Re: North Houston Highway Improvement Project – DEIS Review

The following are the Houston Parks Board's [HPB] comments regarding the DEIS for TxDOT's North Houston Highway Improvement Project. Having participated in the scoping process and subsequent discussions on this project, HPB contends that the DEIS does not fully respond to the significant impacts on parks and open space created by the proposed project. In particular, the project significantly decreases greenspace along White Oak Bayou Greenway north of downtown and Little White Oak Bayou south of I-610. As a result, HPB requests that TxDOT prepare a Supplemental Environmental Impact Statement to more fully address those impacts and develop creative strategies to minimize and mitigate them with additional green space improvements along the corridor.

Segment WOO1: Before I-45 Expansion

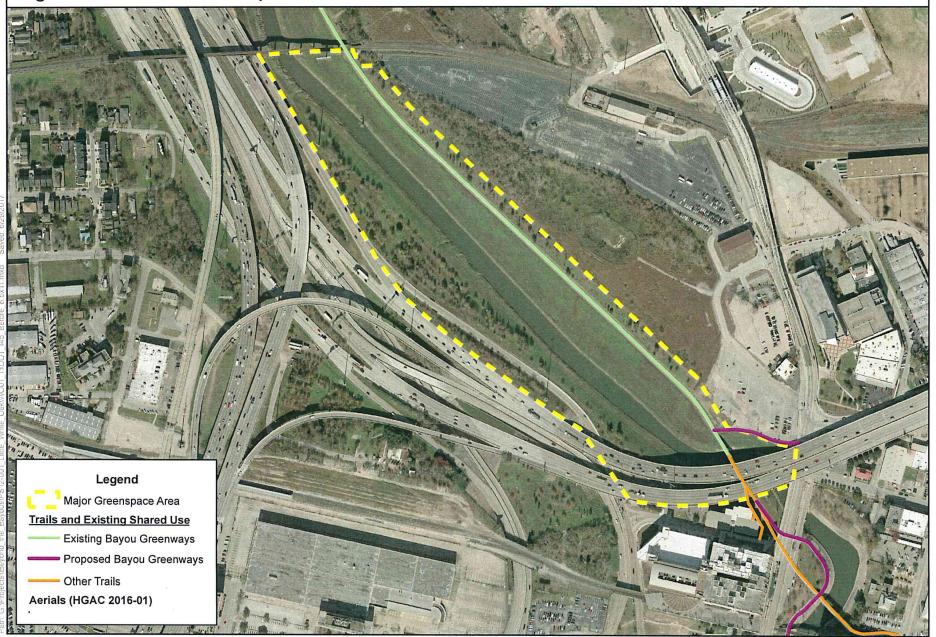
The 1,100 feet of White Oak Bayou Greenway from the current I-45 overpass at UH-Downtown west to Hogg Park is completely open to the sky and the bayou except for small under-crossings at the rail bridge and Hogan Street. The linear park features wildflowers and a hike-and-bike trail maintained by HPB. It offers amazing views of downtown. We are very concerned that the sense of open space will be negatively impacted by the North Houston Highway Improvement Project. The project will extend seven new highway overpasses over the greenway's widest stretch. Currently, only the existing I-45 overpass impacts the greenway, and because it sits right against the massive UH-Downtown building, it is more part of the urban infrastructure. The new overpasses will create an intrusion into the landscape. Moreover, additional lanes parallel to the bayou encroach further into the south side of the greenway to the point where they impose on the bayou itself.

The DEIS appears to suggest that if the project maintains just the hike-and-bike trail, no impact results. That ignores the impact to the greenway and open space itself of which the hike-and-bike trail is just a component. The project eliminates that open space. While the project will remove some freeway, HPB estimates a net increase of 18 acres of open space effectively covered by the project in just the stretch between UH Downtown and Hogg Park. The DEIS does not identify this as an impact, but it certainly is one, and the DEIS should offer alternatives or mitigation to minimize that impact.

Segment WO01: After I-45 Expansion

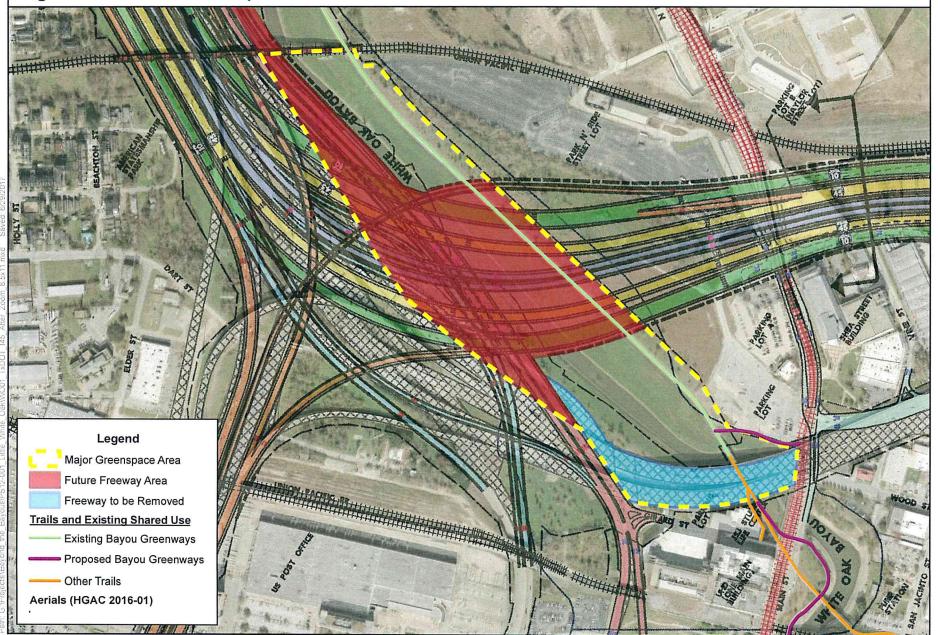
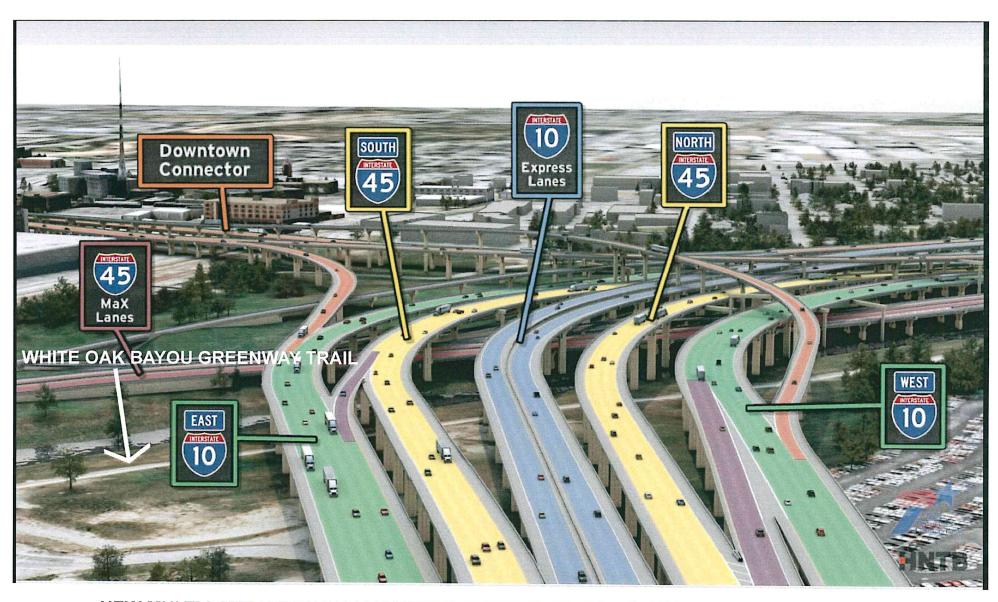
NEW MULTI-LANE FREEWAY ALIGNMENT OVER WHITE OAK BAYOU OPEN SPACE AND TRAIL

Segment WO01: After I-45 Expansion

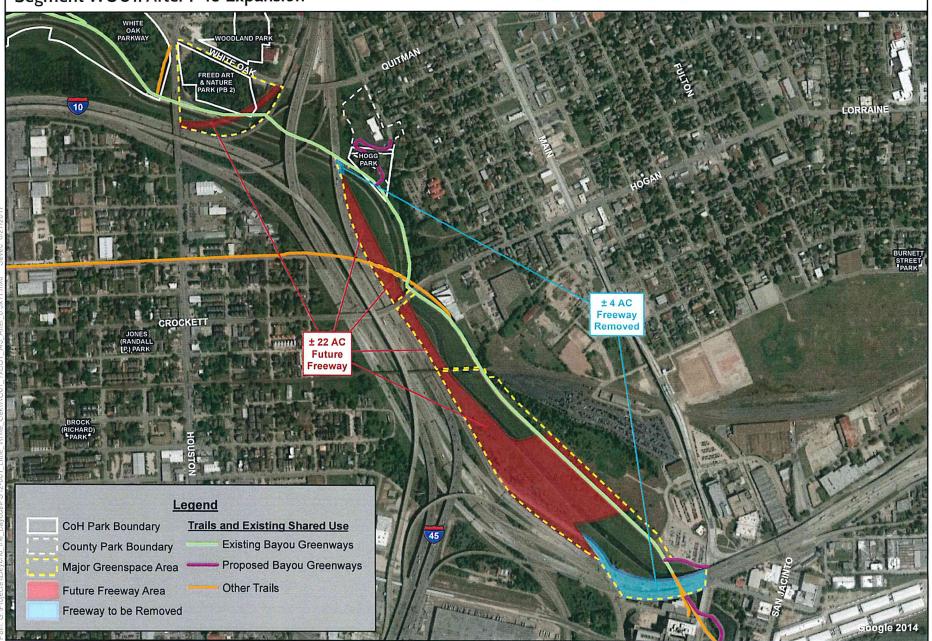
Little White Oak Bayou represents a prime opportunity to extend open space connectivity north from White Oak Bayou Greenway to Woodland and Moody Parks and beyond up to Halls Bayou. The 20 lanes at I-45 will eliminate 10 acres of open space along Little White Oak Bayou. We are currently in the process of expanding the Bayou Greenways network to include Little White Oak Bayou from I-10 to at least Crosstimbers with an extension to Acres Homes, an area of the city not currently served by trails. This connection would benefit many of the underserved communities directly impacted by the North Houston Highway Improvement Project. Through most of Segment 2, the project follows the course of the Little White Oak Bayou. An old TxDOT trail runs north from Moody Park along the bayou. We recommend the DEIS be supplemented with specific design features to preserve the ecological values and open space potential of Little White Oak Bayou including:

- a. Providing bridge spans and trail underpasses where I-45 crosses Little White Oak Bayou;
- b. Building a continuous shared-use trail from Woodland Park to Crosstimbers;
- c. Designing detention basins to be fully-functioning recreational green spaces along the greenway;
- d. Providing for a safe trail corridor through the I-610 interchange;
- e. Coordinating land acquisition to maximize green space, especially north of I-610;
- f. Spanning Halls Bayou to preserve the opportunity for extending the Halls Bayou Greenway;
- g. Provide meaningful connections to dedicated, on-street bike connections feeding into the Little White Bayou as identified in the Houston Bike Plan; and
- h. Maximizing public access and park opportunities for any highway decking through the Woodland Heights neighborhood.

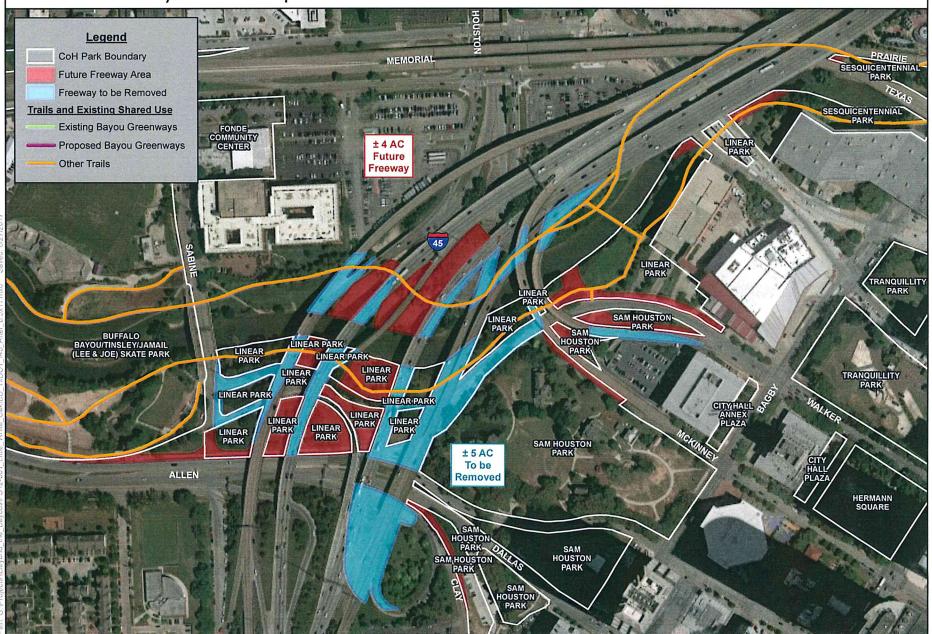
The DEIS identifies less than one acre of impact to City of Houston Parks. It dismisses that impact as related to marginal greenspace rather than the "use of facilities." HPB calculates the total loss of open space in City parks at 3.27 acres (table attached). Thus, as it does with the greenways, the DEIS dismisses the impact to green space and open space as non-existent if the project does not impact active features of the park. The greenspace impacted is the park and therefore should be recognized as such regarding mitigation.
